SELWYN DISTRICT COUNCIL

URBAN DESIGN REVIEW

Of Foodstuff's application RC216016

For a Pak'n'Save supermarket on the corner Levi and Lincoln
Rolleston Roads, Rolleston

Figure 3- Location and Elevation Plans along Rolleston Drive consented Pak'n'Save

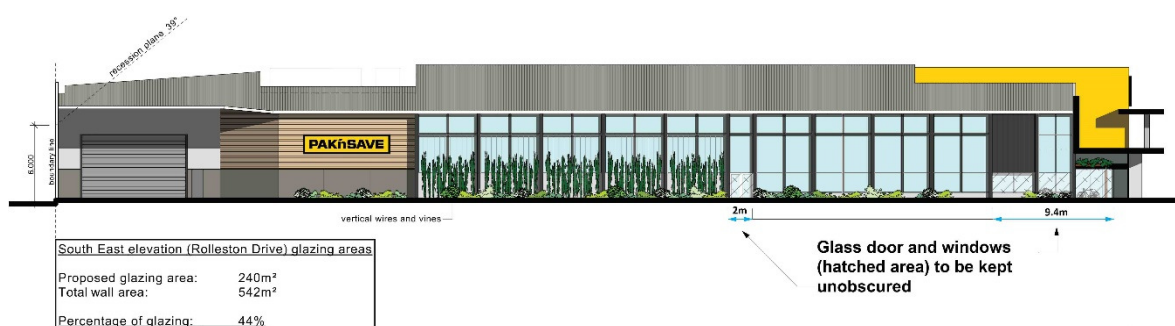
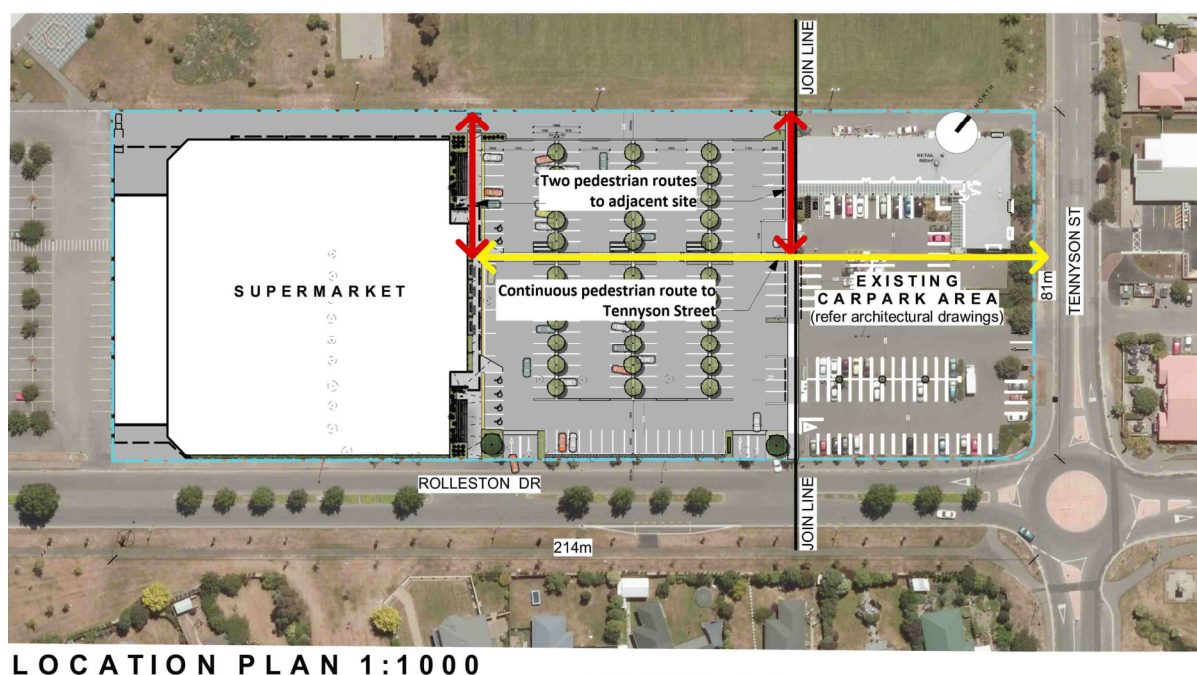
Having reviewed the site and elevation plans for the consented Pak'n' Save (see below) and it's layout I am unsure about Mr Burns assessment that there will be a blank wall along Rolleston Drive or open parking when in fact this proposal achieved not only an active frontage along public space (by providing 40% of glazing at Ground Floor level along Rolleston Drive), but has also subsequently placed car parking to the side of the building. Additional pedestrian routes were part of this consent ensuring an integration with existing shops and aligning with future routes under ODP 29C(i) as and when a connection to the new town centre could be facilitated, thus providing an opportunity to fully integrate the supermarket with the remainder of the town centre.

I disagree with the UD assessment in terms of the provision of active frontage within the previous consented Pak'n'Save on Rolleston Drive. In my opinion this proposal was a successful example of integrating a supermarket within a town centre context.

Figure 4-Shadow model (McCoy Wixon Architects)- Winter solstice 9 am

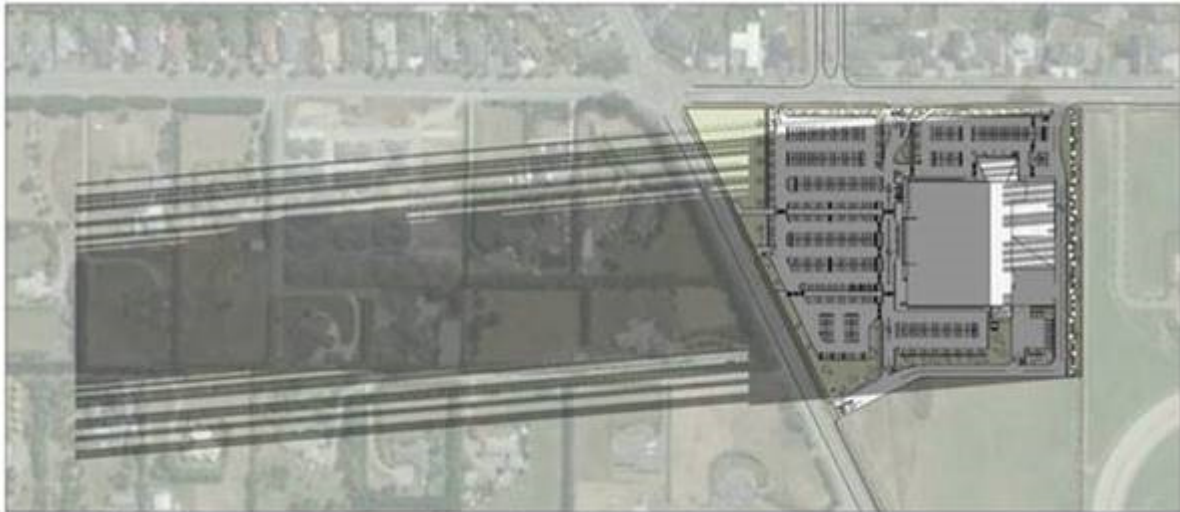
- To determine the extent of the shading as illustrated in Figure 4 a comparison of the effects of the supermarket to a likely built form as if developed under the new EHS Act would confirm extent of effects on adjacent sections and OPD 9

I have reviewed Mr Burns assessment in terms of effects of adjacent neighbours and the effects of the proposal in terms of visual amenity and shading. I have also requested the extent of the shading to be shown on the Lincoln Rolleston Road frontage and the residential sites to the West, which are currently larger Living Z zoned sections. From the findings of this particular shadow model (see Figure 4 below) I conclude that there will be shading effects on adjacent residential properties at certain times of the year and for a period of time.

I consider that this shading will impact the current and future housing on these residential sections, which won't be able to be mitigated. A comparison of the effects from possible future residential development under the new EHS Act, as opposed to the proposed supermarket building on site would be helpful to determine the extent and difference in shading on adjacent sites along Lincoln Rolleston Road and within ODP Area 9.

I consider that shading from the supermarket building along this boundary will impact current and future housing on residential sections along Lincoln Rolleston Road, as illustrated in above figure, which are likely not able to be mitigated due to height and bulk of the built form. For clarity on this matter I suggest a comparison to be done of the effects from possible future residential development under the new EHS Act, as opposed to the proposed supermarket building.
